MONACO RV

## Converter Neutral Wiring

Recall Numbers 11V376000 US and 2011- 267 CA  
Monaco File 11515

R-Vision: 2011 Onyx, Trail Sport, & Trail-Lite Crossover Travel Trailers

Fig. 2—Neutral wire connected to ground bar. **INCORRECT**

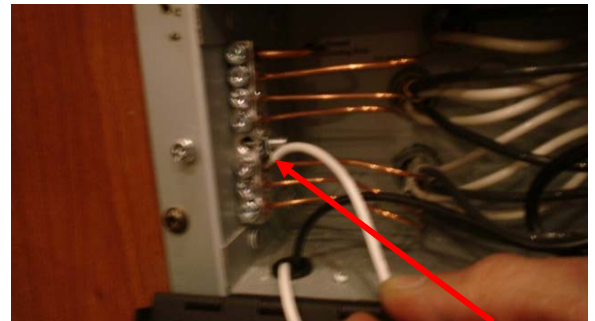
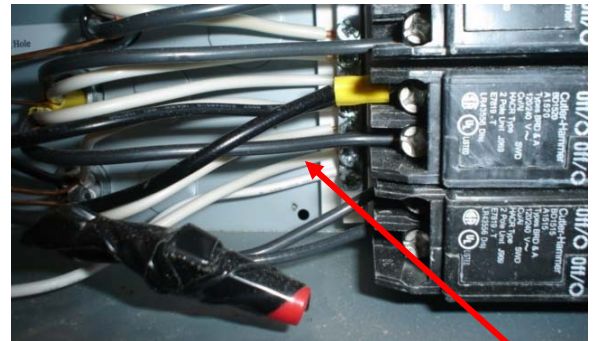
- Remove the metal cover over the 110V load panel by removing the two screws — see figure 1.
- Find the location of the converter neutral wire (white).
- If the converter neutral wire is connected to the ground bar, follow the repair process—see figure 2.
- If the converter neutral wire is connected to the neutral bar, it is correct and no repair is necessary—see figure 3. Reinstall the metal cover for the 110V load center.

- Remove the converter neutral wire from the ground bar and route over to the neutral bar and secure —see figure 3.
- Reinstall the metal cover for the 110V load center.
